Denial Memorandum

Applicant: John Timoni and Michele Leiro
Address: 105 South Ward Avenue, Rumson, NJ 07760
Block 139, Lot 22, Zone: R-5

I have reviewed the revised Land Use & Development Permit application for improvements at 105 South Ward Avenue in Rumson. The existing lot is a slightly oversized, conforming lot in size and shape. The existing principal dwelling is at the maximum permitted floor area for this lot. It is a nonconforming building due to the minimum side yard setback (3.42' existing, 8' required) and combined side yard setback (13.8' existing, 18' required). The applicant proposes to raise the dwelling approximately 6' for flood compliance and to add garage/storage below; install a new, expanded foundation; additions to the front, side and rear; realign driveway for new garage below; and replace the rear deck and steps in the rear yard setback.

PLOT PLAN
 Scale: 1/16"=1'-0"

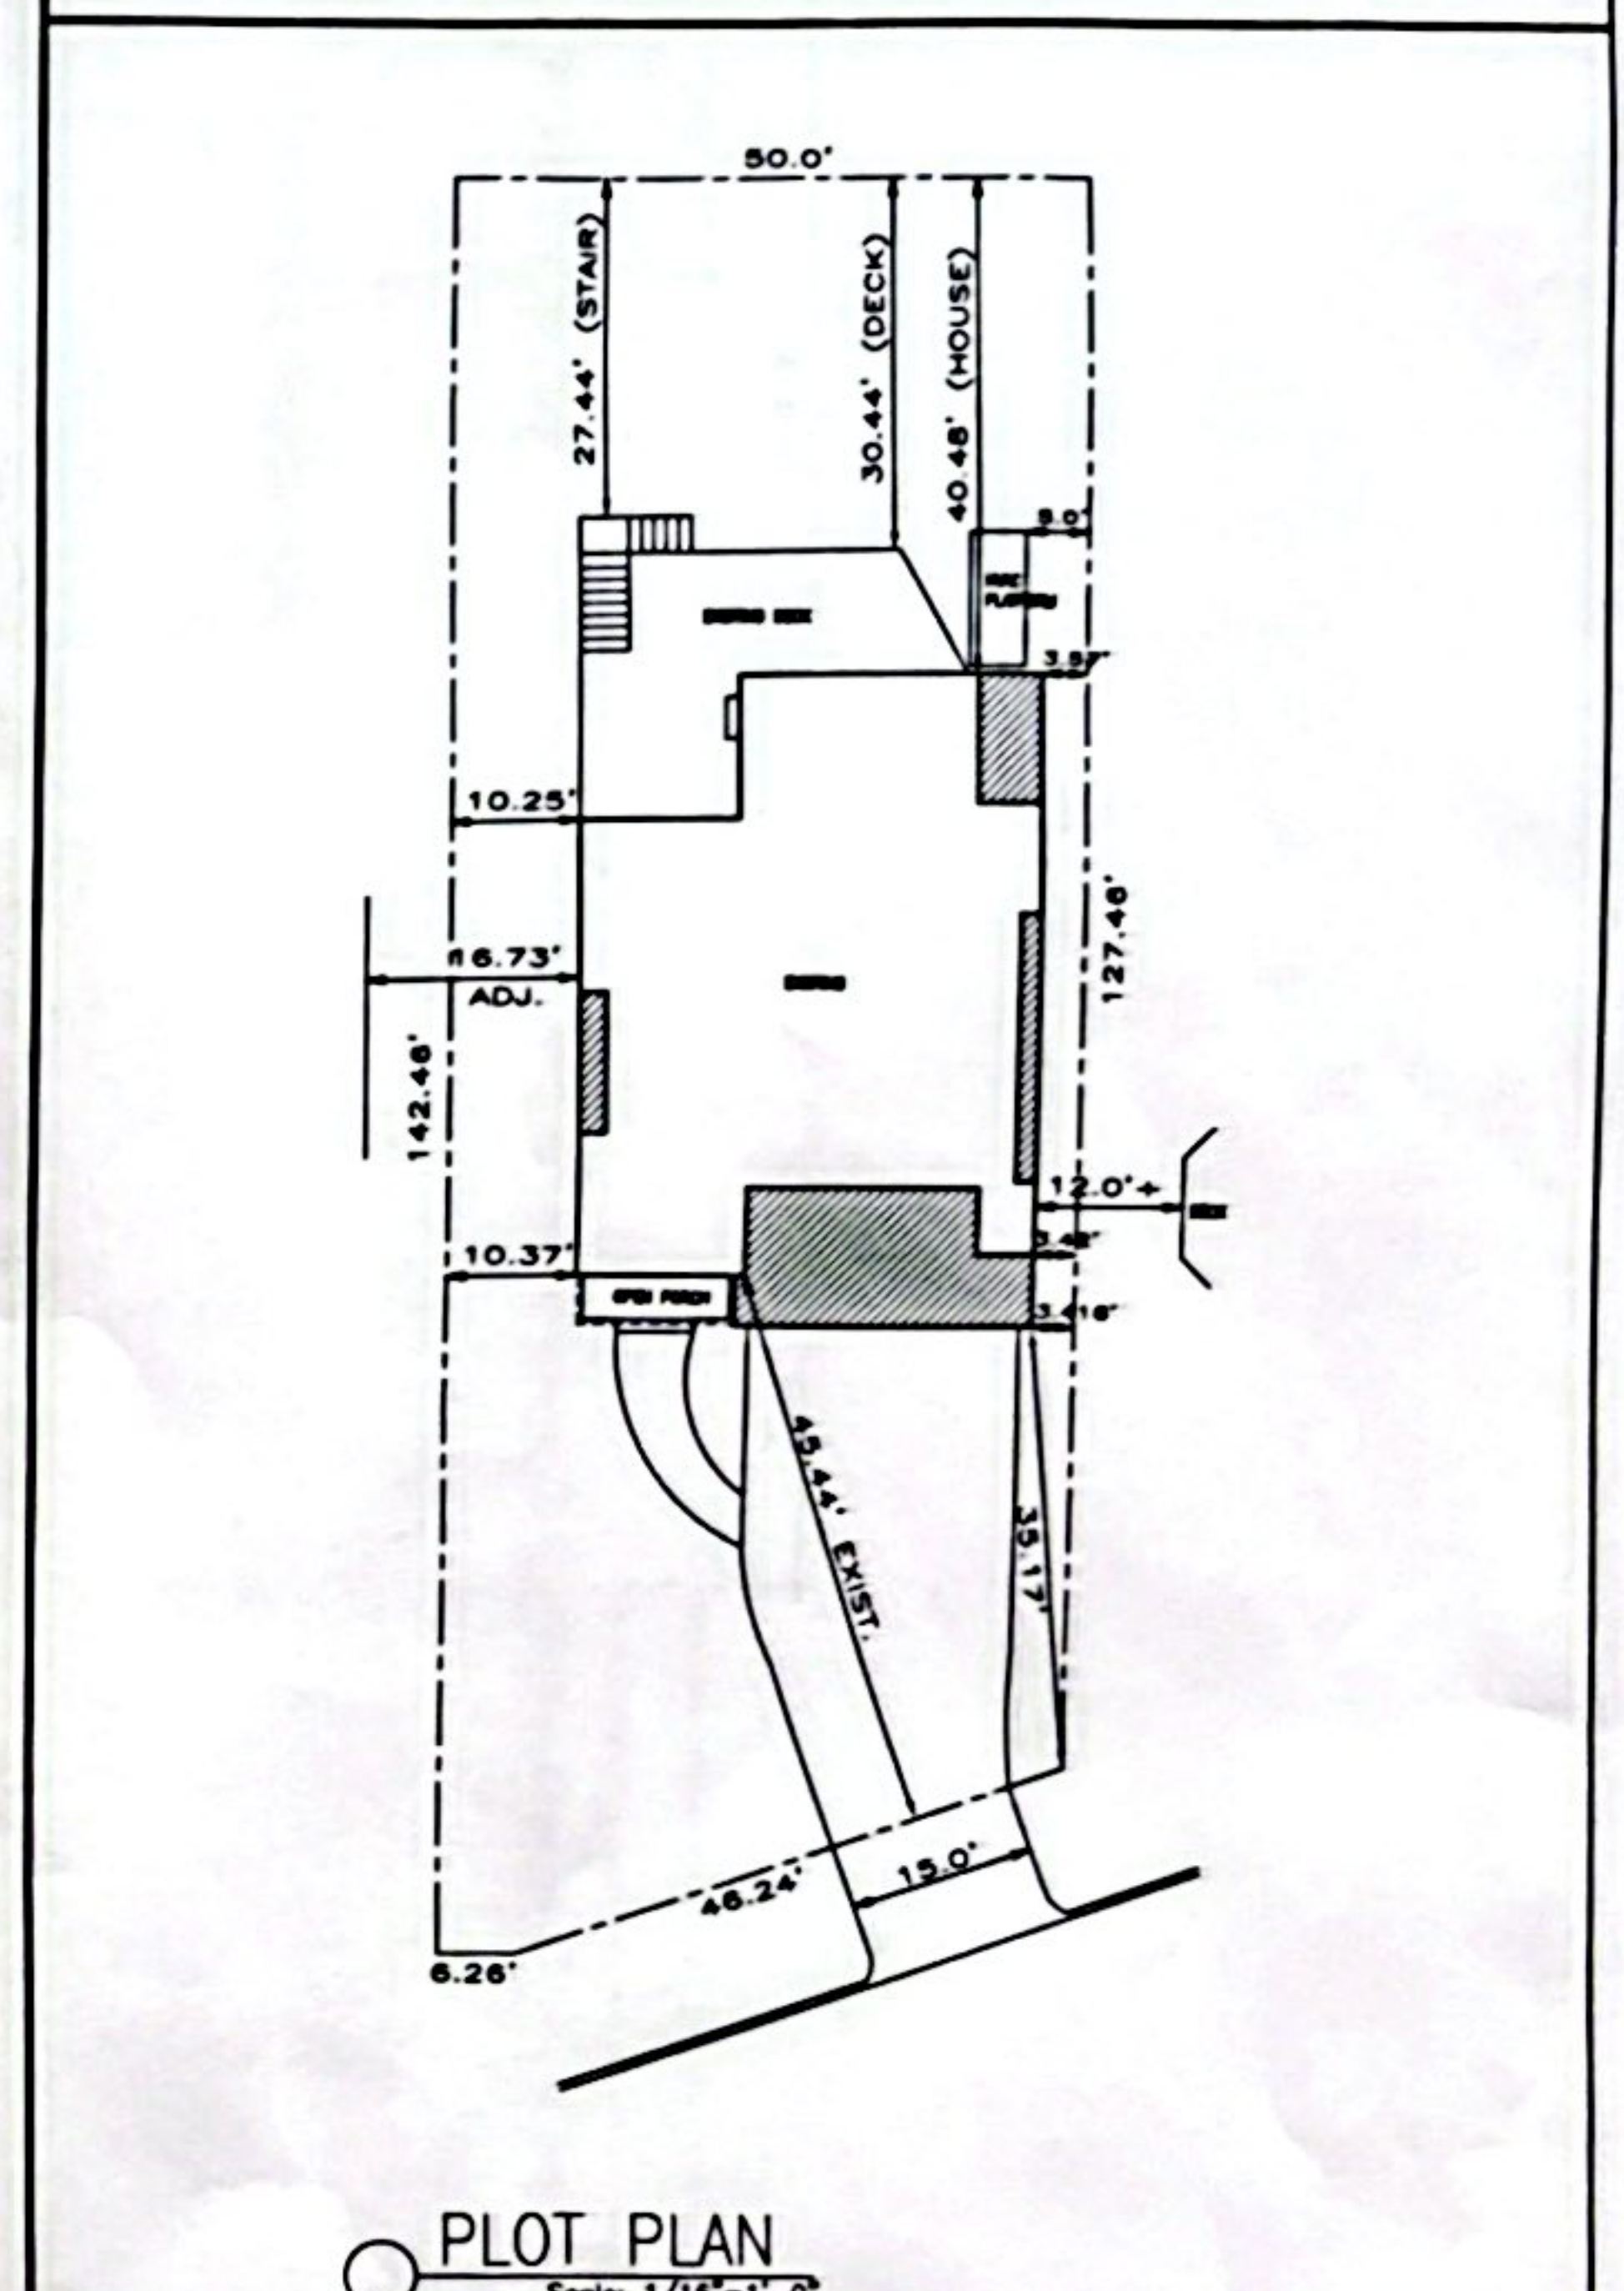
- Expansion of habitable space in a nonconforming dwelling **(22-7.3 New)**
 - Lifting dwelling while intensifying side yard setback nonconformity with two additions and creating a 51.5' linear wall.
(Sched 5-1 Existing nonconformity – Intensified)
- Buildings with a linear side greater than 35' long are required to add an additional 2' to the required SYSB. **(22-7.7g New)**
- Maximum FAR of 0.51, whereas 0.37 is permitted, and 0.37 is existing. **(Sched 5-3 New)**
- Maximum Floor Area of 3,497 SF, whereas 2,538.5 SF is permitted, 2,525 SF is existing. **(Sched 5-3 New, 38% over)**
- Maximum Building Coverage of (1,782) SF, whereas 1,499 SF is permitted, 1,351 SF is existing. **(Sched 5-4 New)**

- Lot depth (Borough definition) is 130'.
 - The proposed rear raised deck with rear setback of 30.4' whereas 39' is required. **(Sched 5-1 New)**
 - Entry steps in a flood zone are permitted to extend an additional 5' in the RYSB. Proposed rear steps setback at 27.4', whereas 34' is required. **(Sched 5-1 New)**
- Proposed dwelling ridge height at 44.0 whereas 2022 BFE is 8. Therefore, the proposed dwelling ridge height exceeds the permitted 35' building height. **(Sched 5-2 New)**

- The lot coverage was not updated for the driveway realignment.
- Please provide a conforming location for future generator installation.
- The extent of the project's foundation and additions on three sides of the dwelling result in more than partially damaging the existing dwelling. The applicant should be prepared to discuss how the existing dwelling is exempt from the restriction to rebuilding/expanding a dwelling that is more than partially destroyed (22-7.3). **(Variance/Waiver required)**
